MSC 81 の審議結果の紹介

テクニカル インフォメーション

No. TEC-0668

発行日 2006 年 7 月 12 日

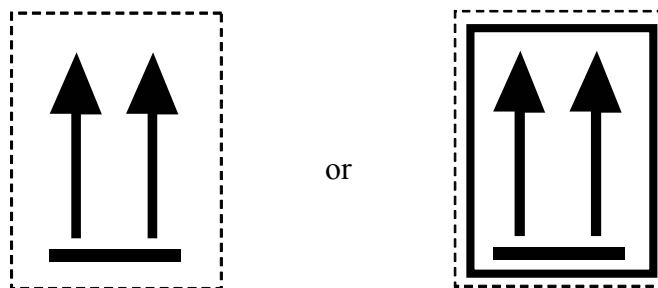
- 5.2.1.4 and 5.2.2.1.7 Add “and large packagings” after “capacity”.
- 5.2.1.5.4.3 Amend the end of the sentence to read as follows: “...origin of design and either the name of the manufacturer or other identification of the packaging specified by the competent authority of the country of origin of design.”.
- 5.2.1.5.8 Add the following new paragraph:
- “5.2.1.5.8 In case of international transport of packages requiring competent authority design or shipment approval, for which different approval types apply in the different countries concerned, marking shall be in accordance with the certificate of the country of origin of the design.”.
- 5.2.1.7 Add the following new paragraphs:
- “5.2.1.7 Except as provided in 5.2.1.7.1:

- combination packagings having inner packagings containing liquid dangerous goods;
- single packagings fitted with vents; and
- open cryogenic receptacles intended for the transport of refrigerated liquefied gases,

shall be legibly marked with package orientation arrows which are similar to the illustration shown below or with those meeting the specifications of ISO 780:1985. The orientation arrows shall appear on two opposite vertical sides of the package with the arrows pointing in the correct upright direction. They shall be rectangular and of a size that is clearly visible commensurate with the size of the package. Depicting a rectangular border around the arrows is optional.

Two black or red arrows on white or suitable contrasting background. The rectangular border is optional
